Dolby Laboratories Inc

Field Bulletin 220

Model CP500 Cinema Processor

Intermittent Cat. No. 675A Failure

Required change

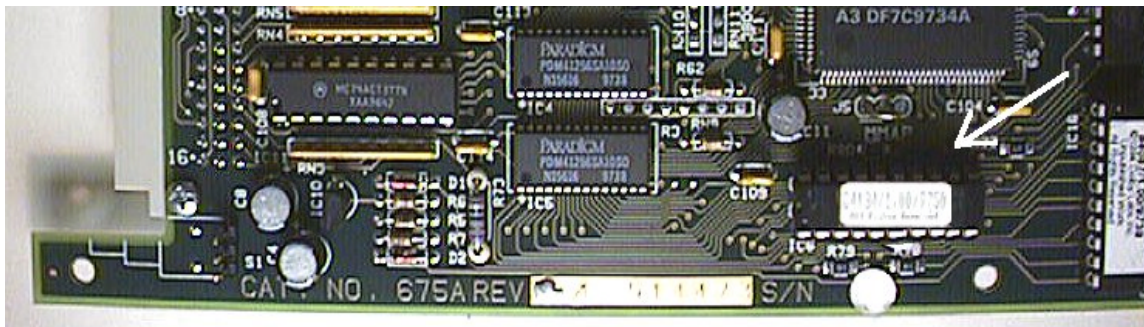
A number of Cat. No. 675A boards manufactured recently have been returned to us because of intermittent failure. Our investigation has pointed to a potential problem with one particular Gate Array Logic (GAL) part used on the board as the part becomes too slow to allow reliable operation at high operating temperatures.

On Cat. No. 675A boards which show any of the Symptoms listed above and with a serial number between 11500 and 16700, the GAL in location IC6 needs to be replaced. This part is located close to the serial number on the bottom edge of the board and can be identified by the label showing the number 84135/1.00/yyww (see below) where yyww indicates the year and week of manufacture of the part.

IC6 is a socketed part and can easily be changed in the field. Replacement ICs should be requested from Dolby Laboratories and the original ICs should be returned to Dolby Laboratories.
